Application Number: Subject: Location/APNs: Applicant: Zoning/General Plan: Entitlement: Environmental Status: 24PLN-41 Plan Revision to replace siding on Priority 2 structure 257 S Auburn St / APN 008-460-044 Jim Meadows Construction Inc. on behalf of Richard Mansfield Neighborhood Center (NC) / Office Professional (OP) Plan Revision – DRC / PC Review Categorical Exemption

Existing Shingled Siding at 257 South Auburn Street

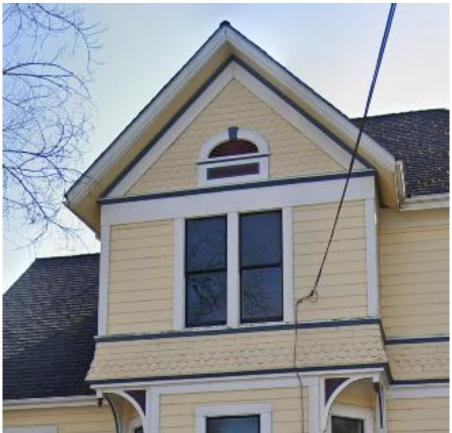
Today, the façade of the building at 257 South Auburn Street is identical to the image recorded at the time of the historical inventory. However, the shingles are shake shingles rather than fish-scale shingles.

The applicant proposes to remove the existing wood shake shingles and replace them with Hardie fish-scale, or scalloped, shingles on four dormers and two gables. The applicant provided the photograph below of the proposed shingles as they currently exist on the structure 307 South Auburn Street. The residence at 307 South Auburn is also a Queen Anne style structure built circa 1897 recorded as a Priority 1 structure in the City's historical inventory. The applicant proposes to change the shingle siding to reflect the defining features of a Queen Anne style residence.

1. The final design shall be consistent with Plan Revision application and plans provided by the applicant and approved by the Development Review Committee (24PLN-41). The project is approved subject to plans on file with the Community Development Department.
